## **SCOTT PLANTATION SUBDIVISION, UNIT NINE**

APPLICATION NUMBER 2 DATE November 5, 2009

REQUEST Subdivision

# DETAIL SITE PLAN

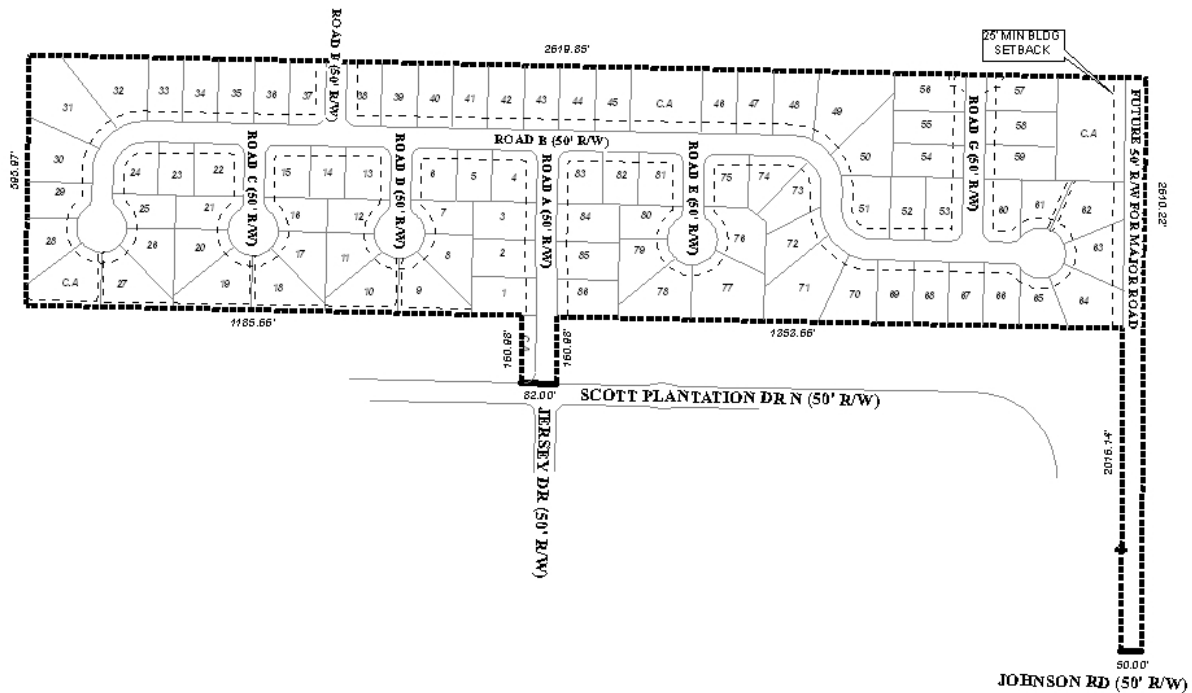
The plat indicates only one access stub to an adjacent parcel to the North. However, there are three adjacent parcels to the North, and the plat should be revised to provide an access through

proposed Lot 56, which would create an additional stub to the undeveloped property to the North.

The proposed subdivision has several cul-de-sacs without central medians, all indicated to have 100' diameter rights-of-way. The 2003 International Fire Code requires a 120' diameter for cul-de-sacs without a central median. Therefore, the plat should be revised to indicate 120' diameters on all cul-de-sacs with revisions to the building setback lines and lot sizes for all lots affected by the increased diameters required.

- 1) revision of the plat to align the access right-of-way via Lot 31, Scott Plantation Subdivision, Unit Eight with the right-of-way of Jersey Drive East and to provide a minimum building setback line along the access for Lot 32, Scott Plantation Subdivision, Unit Eight;
- 2) revision of the plat to provide an additional access stub to the undeveloped property to the North through proposed Lot 56; and
- 3) revision of the plat to provide 120' diameters for the rights-of-way on all cul-de-sacs with revisions to the minimum building setback lines and lot sizes for all lots affected by the increased diameters required.

*A revised plat was submitted addressing the above. However, since that time, the City Legal Department has determined that in order for the applicant to utilize Lot 31, Scott Plantation Subdivision, Unit Eight as access to the proposed subdivision, all of Scott Plantation Subdivision, Unit Eight must be included to resubdivide said Lot 31 into the proposed subdivision. This will entail a revised plat including Unit Eight with all property owners in that unit agreeing to be included. Also, a revised public notification will be required to include all property owners involved and all property owners adjacent to and across streets from both Unit*

*Eight and the proposed subdivision site. As this application has already been heldover once and an extensive revision is required for further consideration, it would stand that denial as currently submitted would be in order.*

- 1) Scott Plantation Subdivision, Unit Eight must be included in order to resubdivide Lot 31 of that unit into this subdivision per a determination by the City of Mobile Legal Department.*
